CALL NO. 200  
CONTRACT ID NO. 255371  
ADDENDUM # 1

Subject: Franklin County, 121GR25D071-STP BRZ  
Letting February 20, 2025

- (1) Added - Special Notes - Pages 40A-40H of 208
- (2) Revised - Material Summary - Pages 149-151 of 208
- (3) Revised - Proposal Bid Items - Pages 206-208 of 208

Figure 1: Threaded rod detail

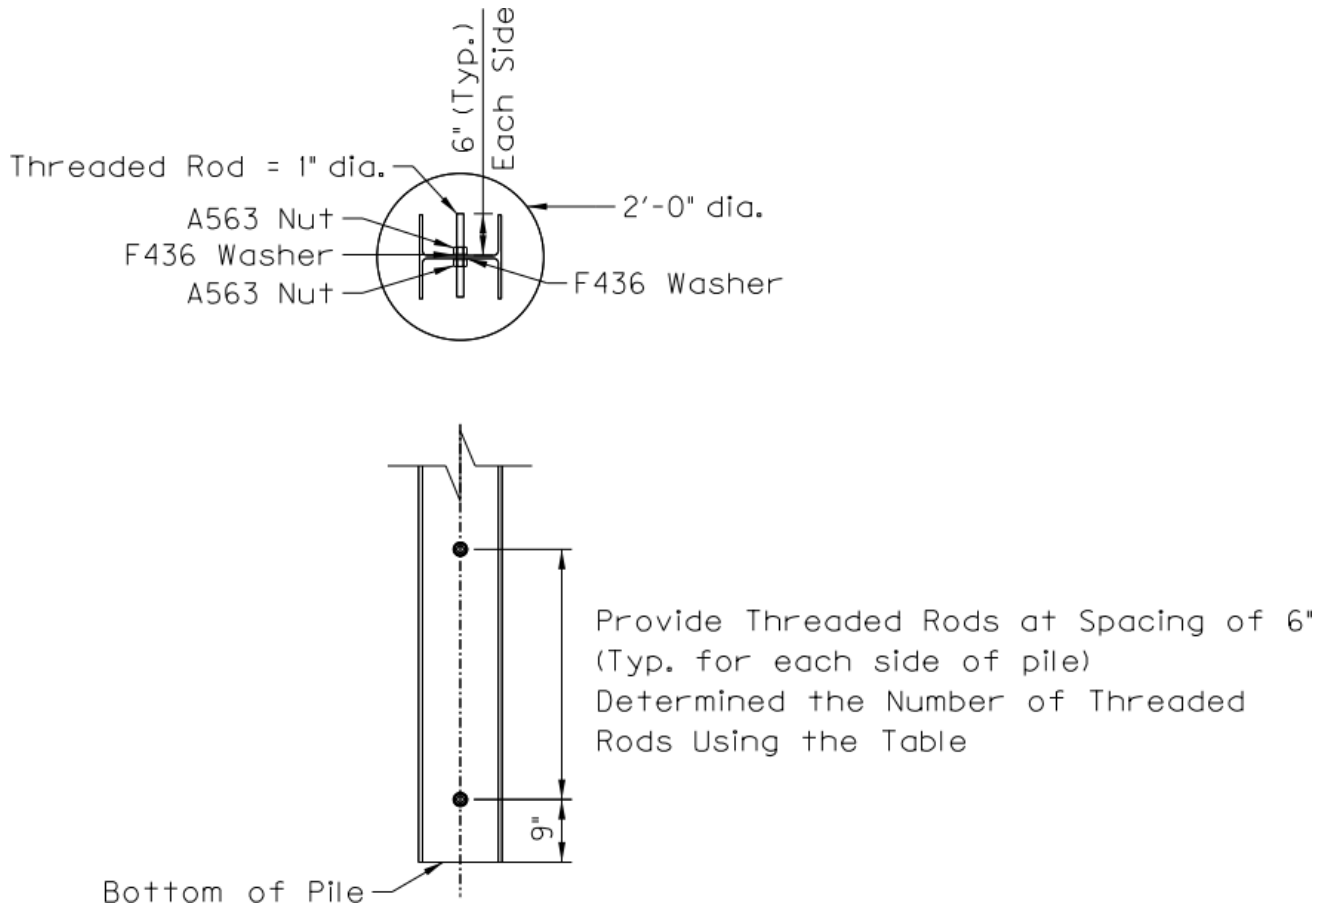
As an alternate to striking the pile with a hammer once placed inside a pre-drilled hole, the contractor may include shear resisting devices on the pile as shown in Figure 1 below. Place pile in hole and use an excavator to apply full hydraulic load to the top of pile before filling hole with concrete. The cost of all labor and materials is incidental to Pre-drilling Piles.

1. Alternate was designed for 125% of the pile design axial load. Required number of threaded rods is provided in Table 1. The piles on this project have a maximum pile design axial load of 61 tons.

2. Use ASTM F1554 Grade 36 threaded rods with a minimum tensile strength of 58 ksi.
3. The minimum depth of the rock socket is 2'-0". Engineer to determine the top of rock elevation.

4. The minimum depth of the concrete backfill shall be 9" above the top threaded rod. Concrete to be Class A or B.
5. Pile points are not required.
6. Provide an excavator with sufficient capacity and reach to lift and place piles without contacting the ground or sides of the boring and to pull casing as the hole is being backfilled.
